SERVICE MEMORANDUM

HOOD SEALING

MGA
MGA 1600

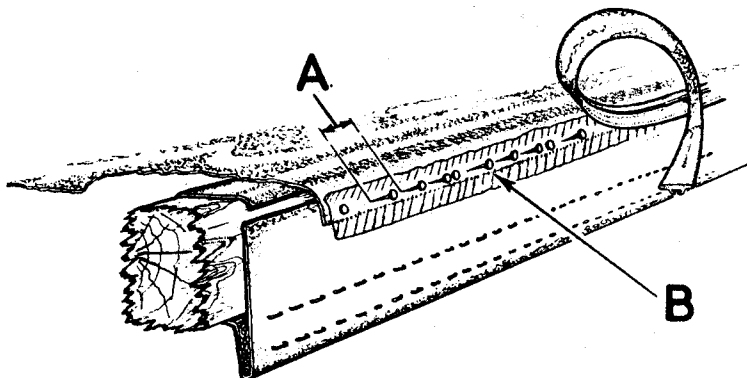
When water is found to be entering the car over the front hood stick, the following method of sealing is recommended.

- Carefully remove the double-cord piping concealing the canopy tacks (Fig. 1)

- Increase the number of tacks securing the hood canopy to give a spacing of approximately $\frac{1}{2}$ " (12.5 mm.) as at 'A' (Fig. 2).

- Brush on a suitable adhesive over the canopy seam $\frac{1}{2}$ " (12.5 mm.) wide as at 'B'.
- Take a strip of P.V.C. leathercloth material, $\frac{1}{2}$ " (12.5 mm.) wide, the length of hood stick and firmly seal down with adhesive directly over tacks and seams as at 'B'.
- Replace double-cord piping.
